TB1150

SERVICE INFO

LuK Part Nr. 225 0050 12 - 250/250mm TGU6 GOLDONI**

New design / Neues Design / Nouvelle conception / Nuevo diseño / Nuovo disegno

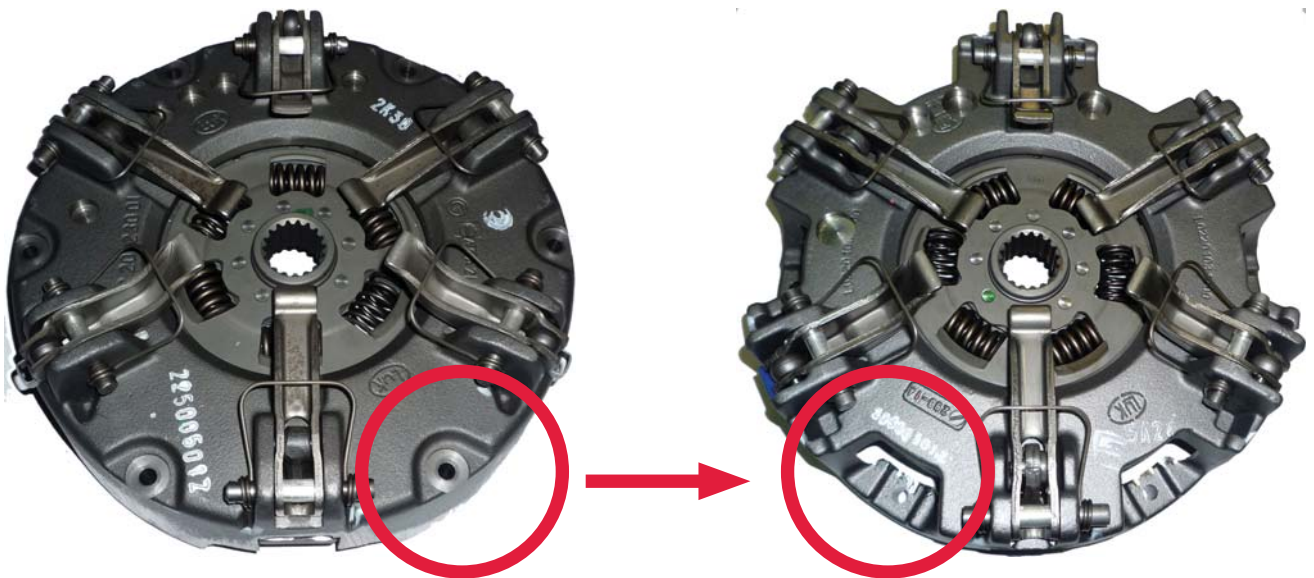
This new design utilises the latest clutch technology, using a vented housing for improved cooling and heat dispersal.

Fully interchangeable with existing clutches with no modifications required to vehicle or flywheel.
A new fixation bolt set **6 x M8 x 1.25 x 45mm** is supplied with new designs to accommodate the lower housing.
